APPENDIX 2

Internal Referrals

FROM: Stephen Poulter, Manager Planning and Environment
TO: GARRY RYMAN, DIRECTOR PLANNING AND ENVIRONMENT
RE: Submission in relation to Development Application 2017/LD-53
FILE: 2017/LD-53
DATE: 12 December 2017

RE: New Health Service Facility and Alteration/Additions to Existing Aged Care Facility

Figure 7.7: Channelised right turn (CHR) on a two-lane rural road

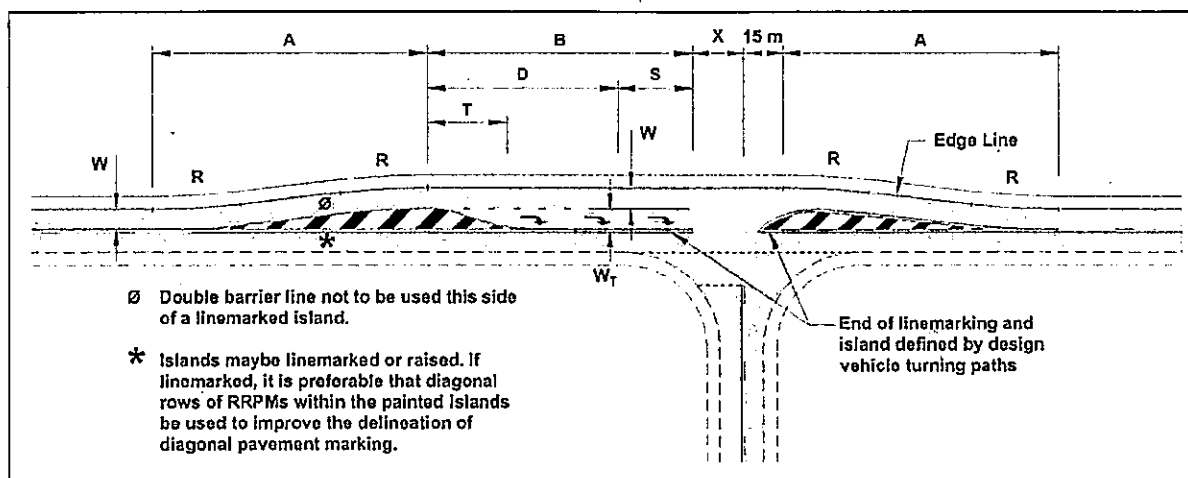
The attached Figure provided by Maurice last week is a similar approach as the child care centre photos you provided me on Monday. Also Maurice raised the issue of Woodiwiss/Lerida being part of the road train route.

I do not believe it is possible to recognise/accept maintaining traffic flow to the south along Woodiwiss while a vehicle turns right into the new facility by merely restricting parking to enable vehicles to continue travelling in the parking lane unless it has the required width and is properly line marked.

The provision of a turning lane in-conjunction with having no stopping on both sides of Woodiwiss appears to be achievable provided that moving the centreline of the road does not mess up the swept paths (to an extent of not being able to be accommodated by an adjustment to design of the vehicle access) of trucks entering and leaving the site.

The other matter identified with a turning lane is the loss of potential for overflow parking in Woodiwiss between Wittagoona and Belagoy. HI current position is that on street parking is available to supplement demands not catered for by the 21 public car parking spaces provided on site. If the above section of Woodiwiss is taken out of the on- street parking pool then available on street parking is limited to Belagoy, Wittagoona, Nullamutt and Woodiwiss to the north of Nullamutt. The problem with this is that the existing pedestrian links to these areas are unsatisfactory and will require upgrading.

Having considered all the issues with vehicles turning into the new facility and the existing traffic on Woodwiss Ave - including the fact that this road is a road train route I think it essential that a right turning lane as shown on the photos I provided to you is installed.

This can be achieved within the existing road formation with revised road marking and elimination of on street parking in the vicinity of the new facility.

Heavy vehicles entering or leaving the facility can still follow existing proposed vehicle sweep paths as the turning bay is there to service light vehicles entering the hospital grounds while still allowing other vehicles continue travelling south on Woodwiss Ave.

The plans Maurice has provided show the dimensions of the required a the length of the 'no parking area' can be finalised when plans for the road marking are prepared.
